August 13, 1992
NRC-92-0095

Subject: Detroit Edison Response to NRC Plant System Branch (SPLB)
Verbal Request for Additional Information on Fermi 2 Power
Update Submittal (TAC No. 82102)

Subject: Responses to NRC Plant System Branch (SPLB) request for
Additional Information on Fermi-2 Power Uprate

SUPPRESSION PUMP TEMP

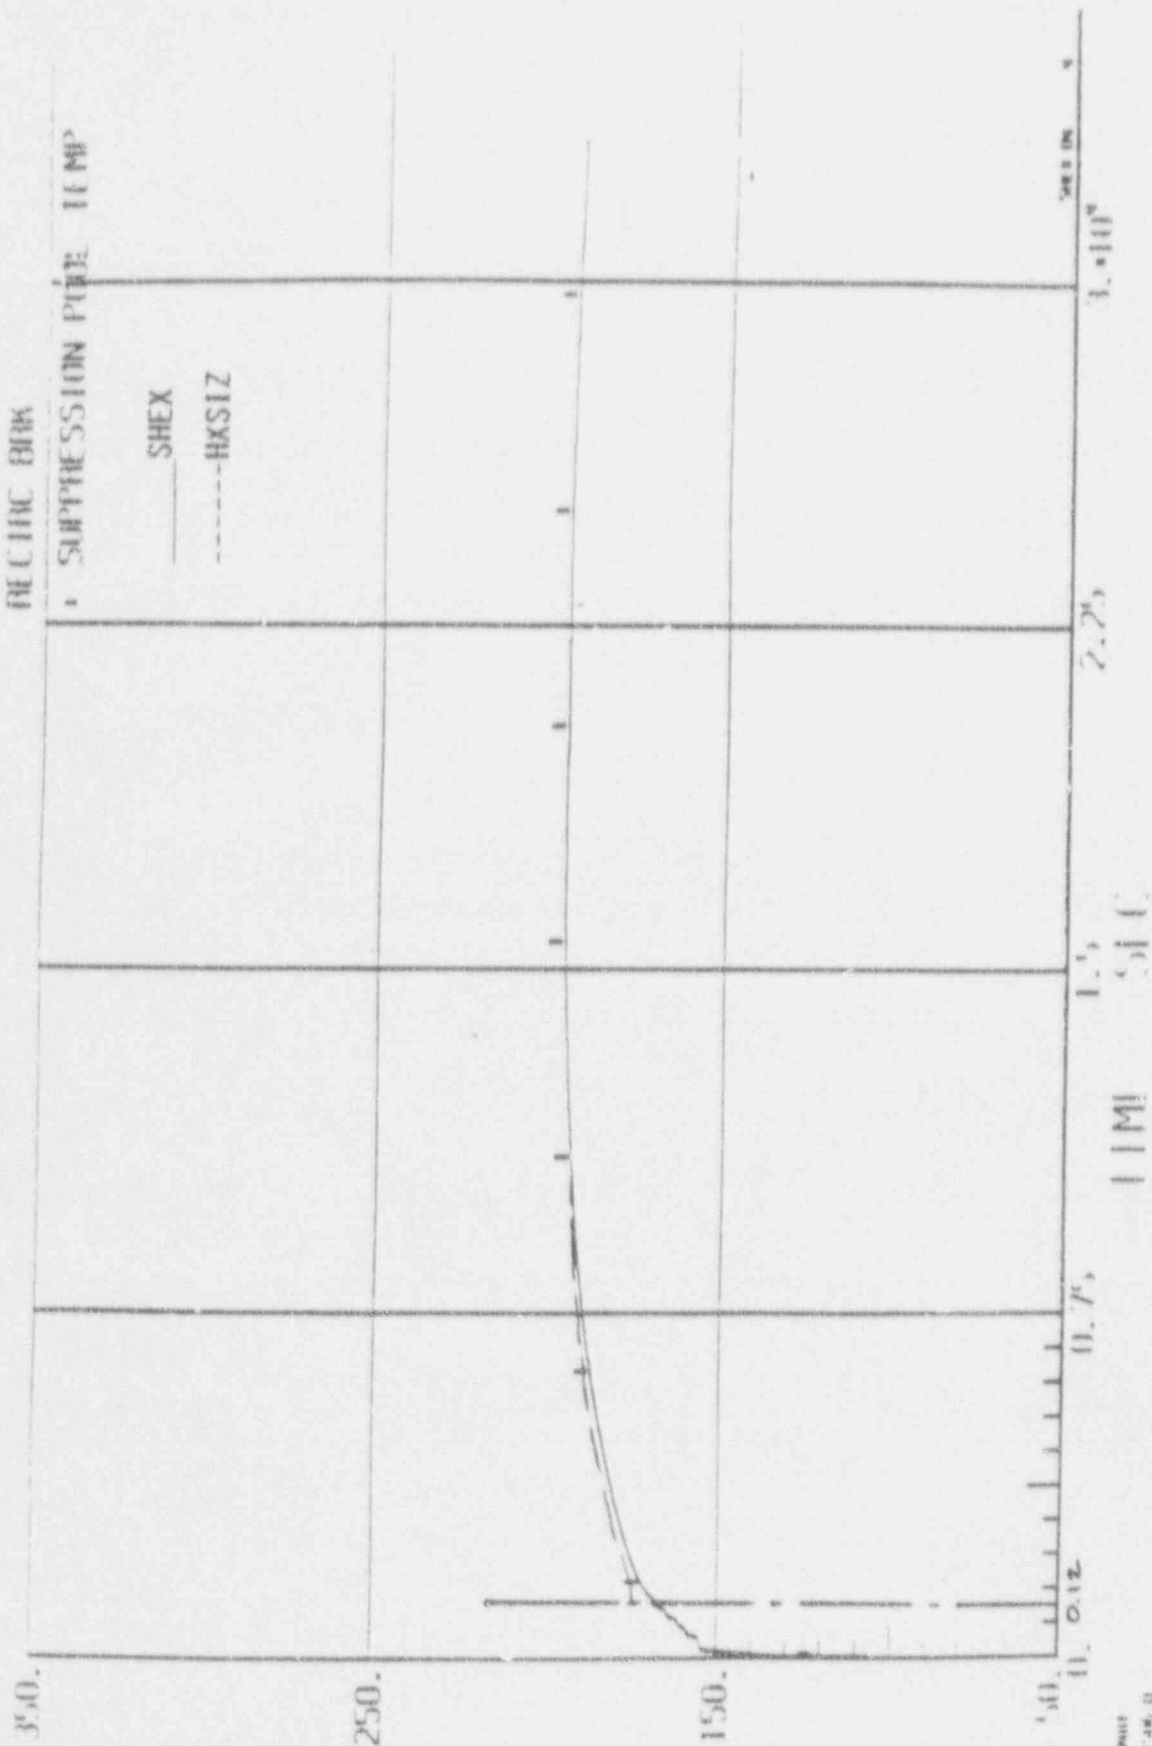
Document the one to one comparison performed between SHEX and HXSIZ performed for the December 1991 meeting. Also, discuss the bases for concluding that HXSIZ was (probably) the code used during the original licensing of Fermi-2.

A comparison of the M3CPT/HXSIZ method and the SHEX code was performed. The important inputs, as presented in Table 3, are identical. The M3CPT/HXSIZ analysis was performed using Power Uprate initial conditions. This was done because the uprated power is the condition of most interest for this comparison. The results of the comparison would also be applicable at a lower power level.

The results of the analysis show that SHEX gives a peak suppression pool temperature of 196.5°F. The M3CPT/HXSIZ codes give a peak suppression pool temperature of 196.1°F. These results are shown in the attached figure. The difference is considered negligible, showing that SHEX is an acceptable alternative to M3CPT/HXSIZ for analyzing the long-term suppression pool temperature response.
